Snap Lake Environmental Monitoring Agency
Main Floor, Lahm Ridge Tower
4501 Franklin Avenue
P.O. Box 95, Yellowknife, NT X1A 2N1
Phone: 867-765-0961 FAX: 867-765-0963
Website: www.slema.ca

Re: Water Licence 2007 Annual Report

The Snap Lake Environmental Monitoring Agency (SLEMA) had reviewed the following documents:

Concentrations of Major Ions over Time

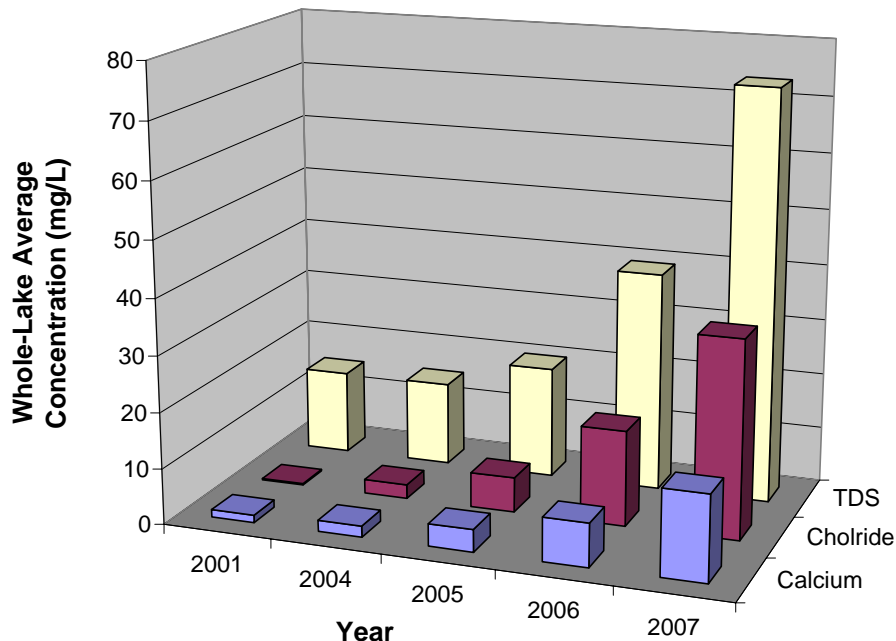
- Section 2.4.2.1, p2-30, Table 2-6: The whole-lake average concentrations of Calcium, Chloride, and Total Dissolved Solids (TDS) have been increasing since the inception of the Snap Lake Project, and the changes are quite significant (see the following chart). Although the values are well below the Environmental Assessment Report (EAR) benchmarks or CCME guidelines criteria, the potential of exceeding those limits over the long-term has been noticed (p2-50). Options to mitigate the trend should be prepared or in place.
